**Subject: Beaver Valley Power Station, Unit No. 1
BV-1 Docket No. 50-334, License No. DPR-66
Reply to Request for Additional Information Regarding
Order EA-03-009 Relaxation Request**

**Responses to NRC Questions
Regarding Beaver Valley Power Station (BVPS) Unit 1
Order EA-03-009 Relaxation Request**

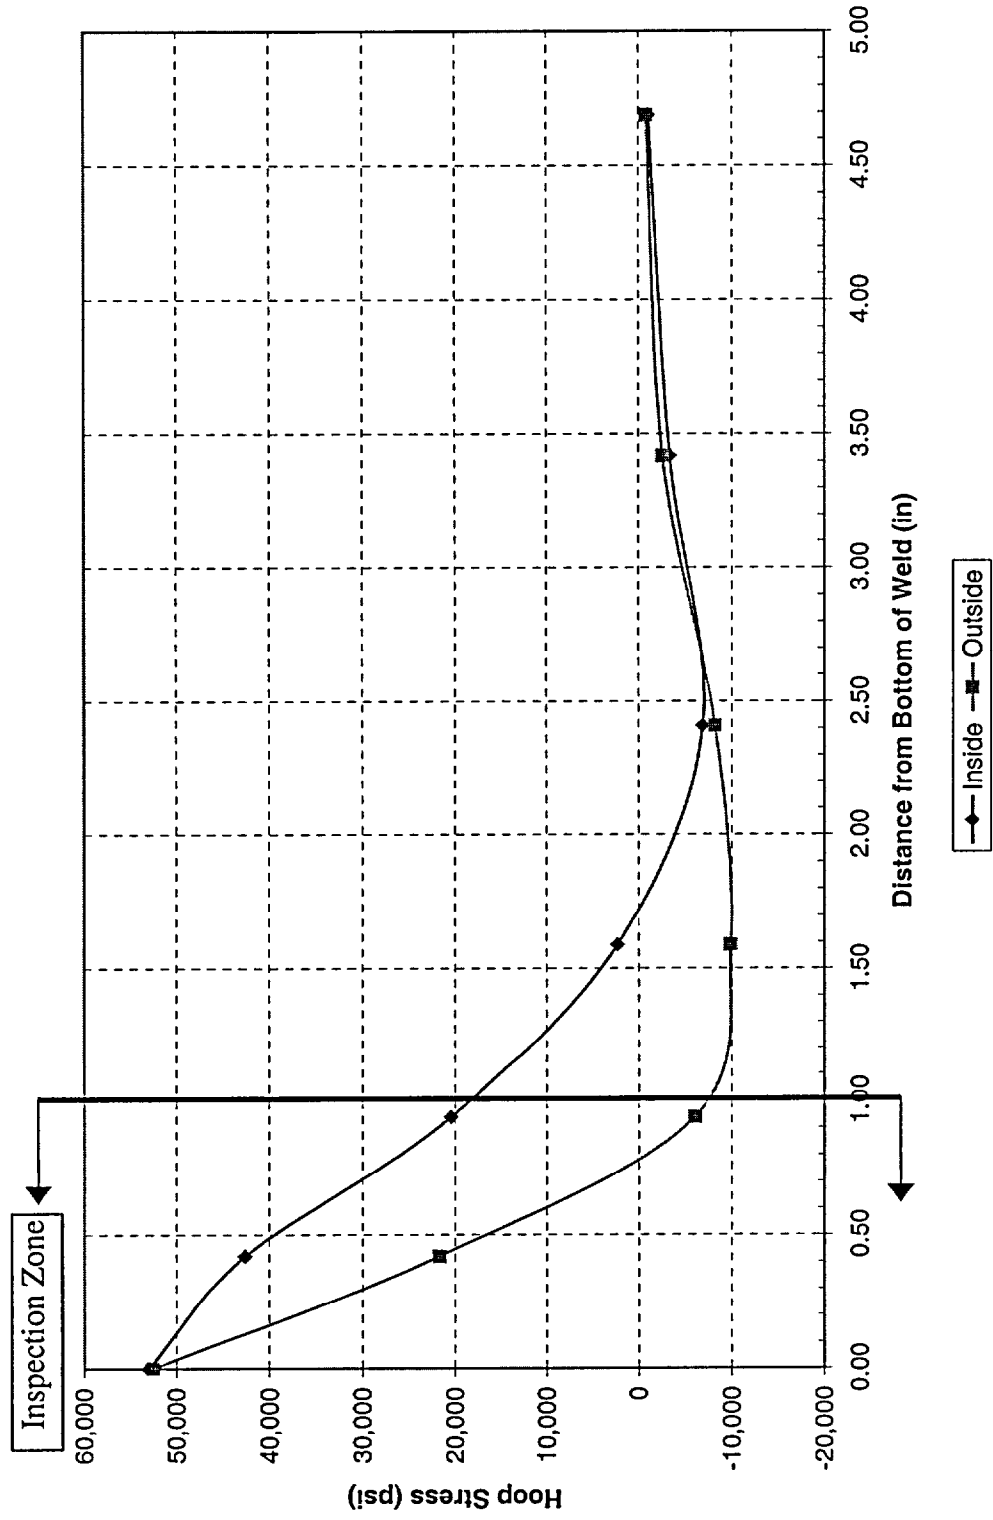
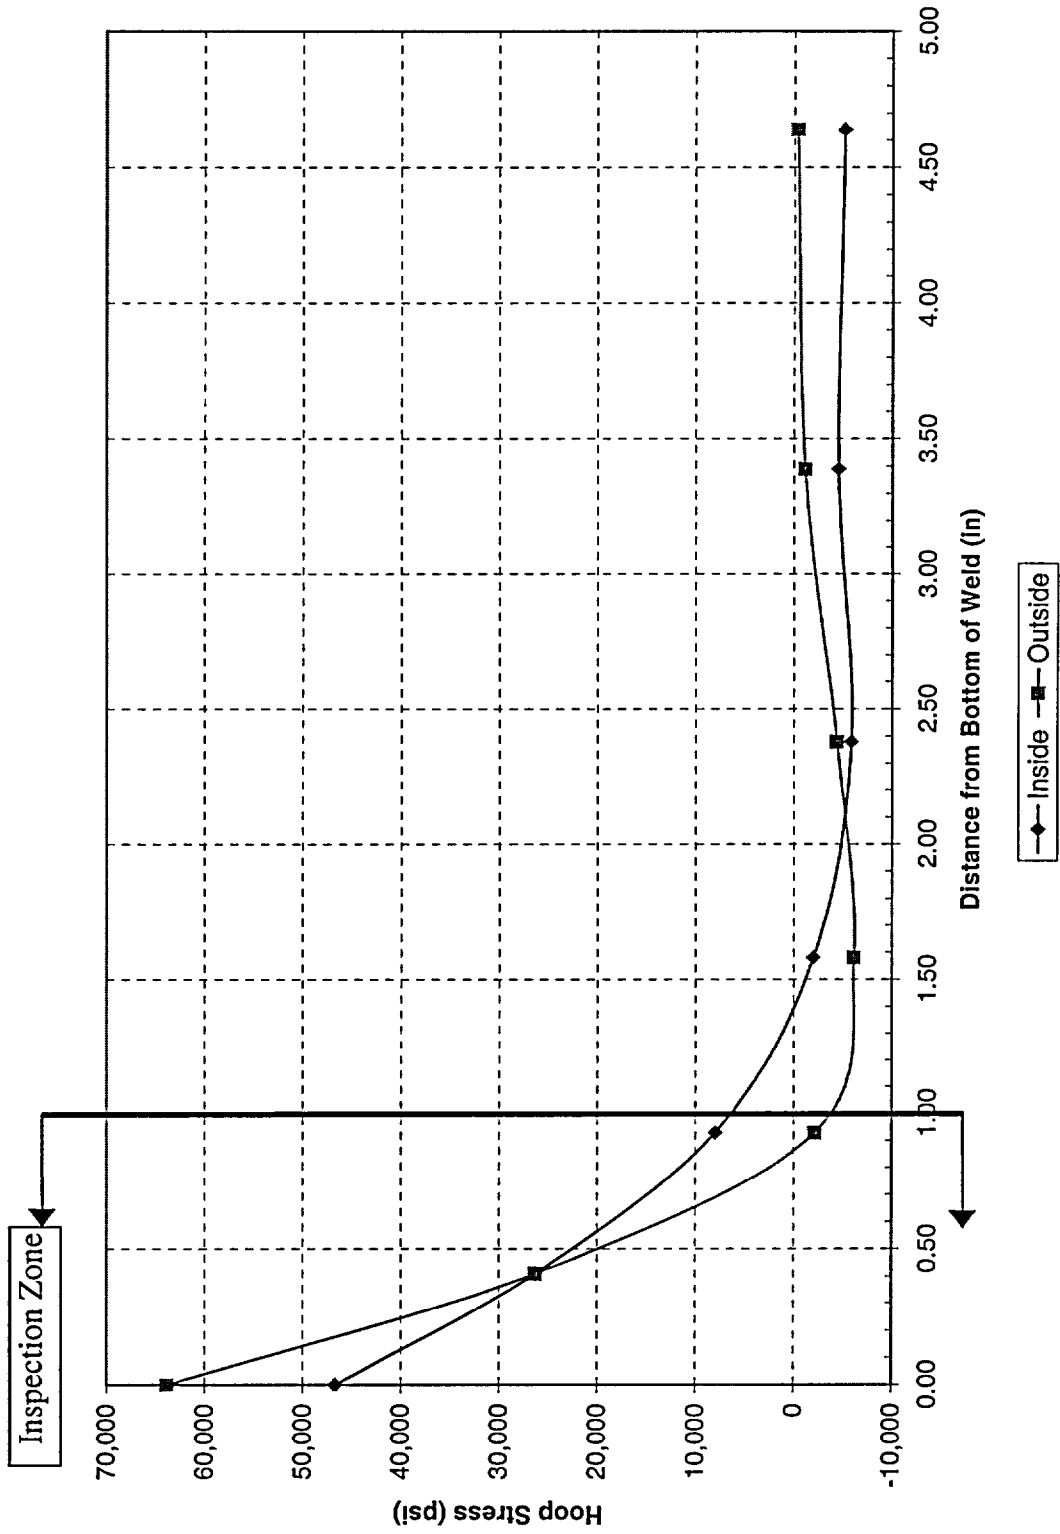
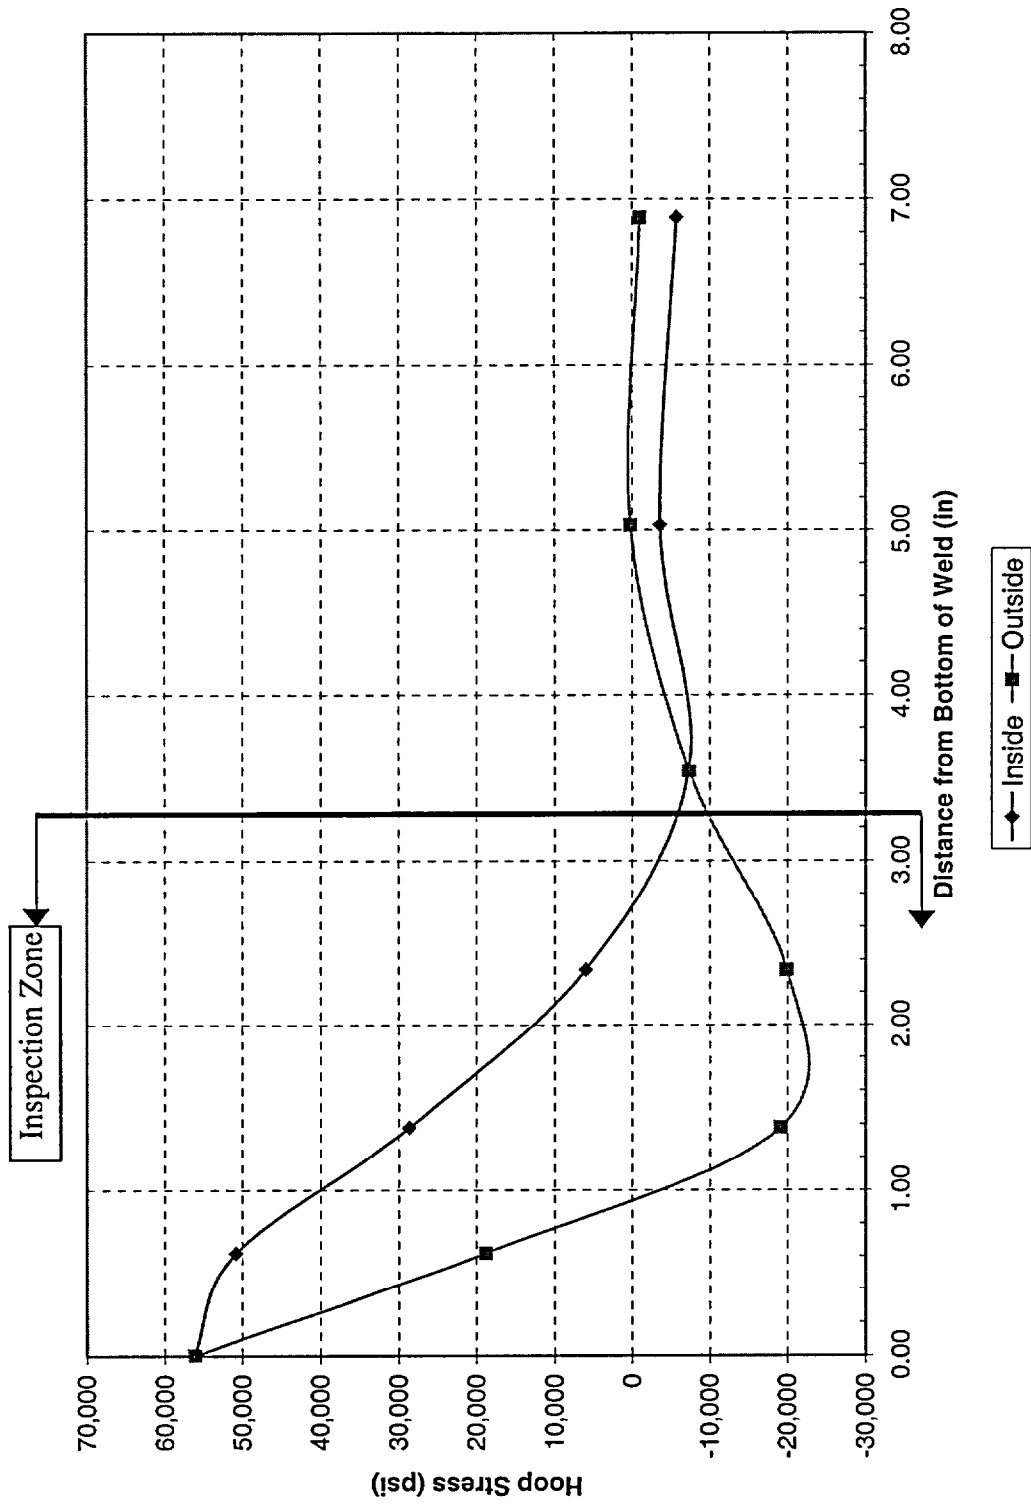
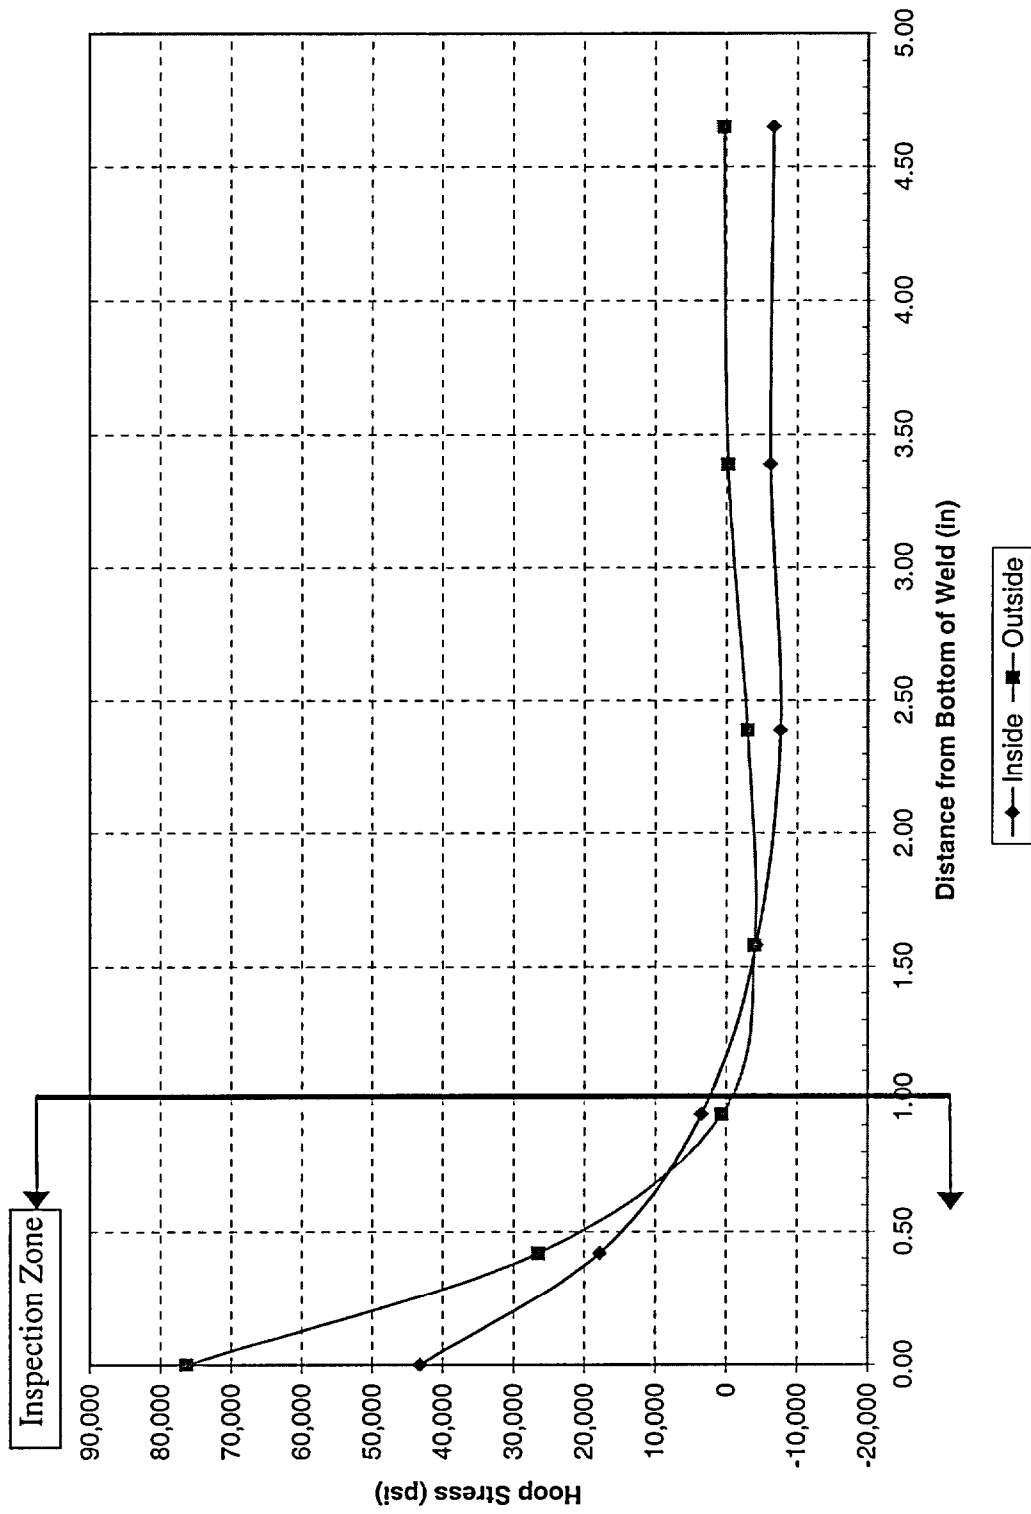
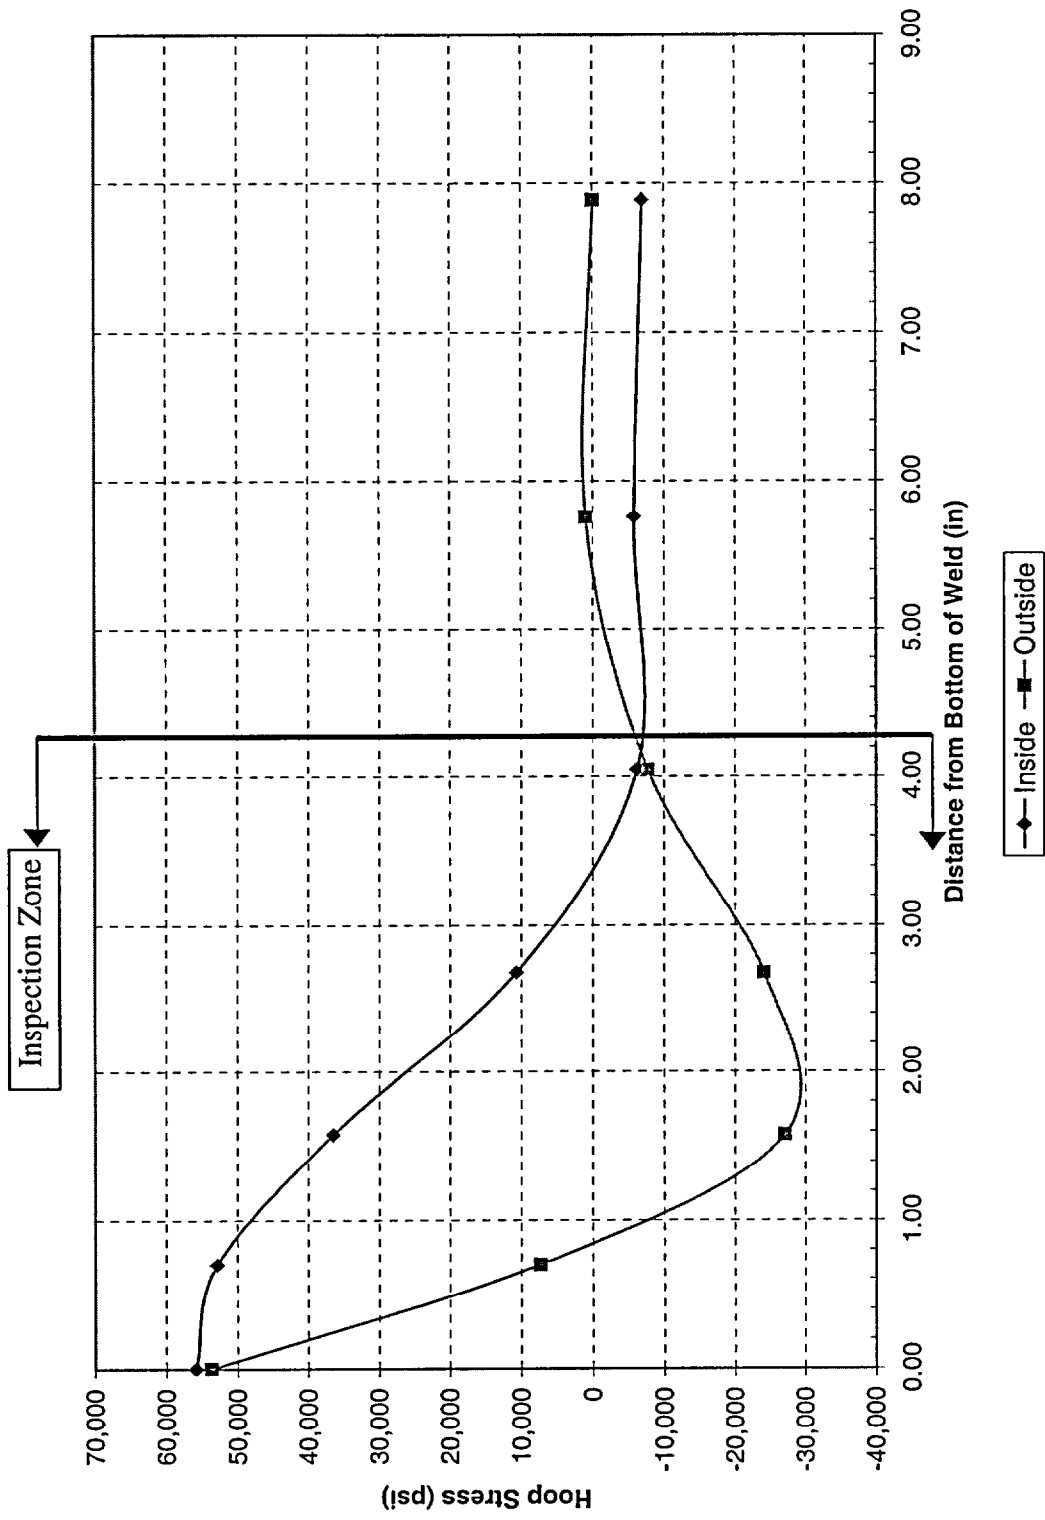
Question 2. *The request states that, "The magnitude of the stresses in these portions of the nozzles is low based on information from other plants of similar design and construction." Discuss how this information is applicable to your plant. Provide tabular listings of the maximum stress in the cross-section from the top of the J-groove weld region to the area covered by your relaxation request.*

The hoop stress distributions as a function of distance from the bottom of the weld for a range of penetration nozzles located at the center of the vessel head to the outermost nozzles are provided in Figures 1 to 9. The expected "inspection zone" is also identified in each figure. This information is provided in graphical versus tabular format. As shown in Figures 1 to 9, the magnitude of the stresses in the unexamined portion of the nozzles is low. See response to Question 3 for further information.
